ADDENDUM NO. 01

CITY OF SAN RAMON

Dougherty Station Community Center Renovation Project (CIP 200004)

LumenArt **Art** Multipoint canopies

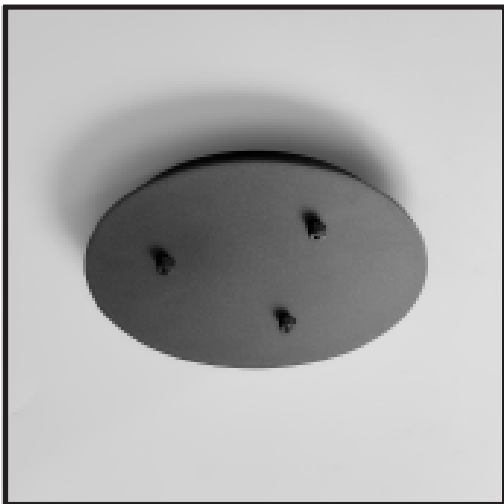
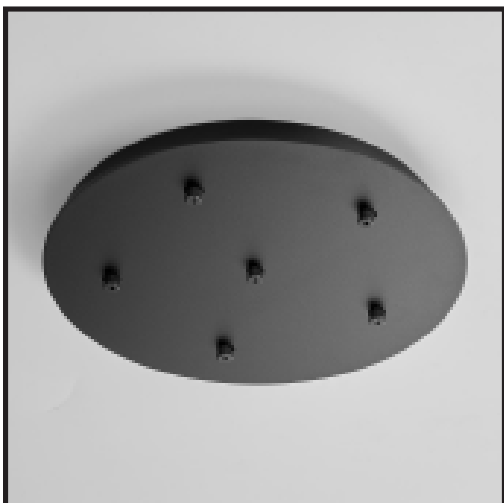
3. Question: Would it be possible to ask the customer the model number for Fixture Type E-CC3?

Answer: Fixture Type E-CC3 is a Pendent/Reception LED to be Lumenart LEP Series Black finish. Contractor to submit proposed fixtures for approval. See **included** cut sheet for specified fixtures on drawing pages A120, A121, A122, A123, A124, and A125.
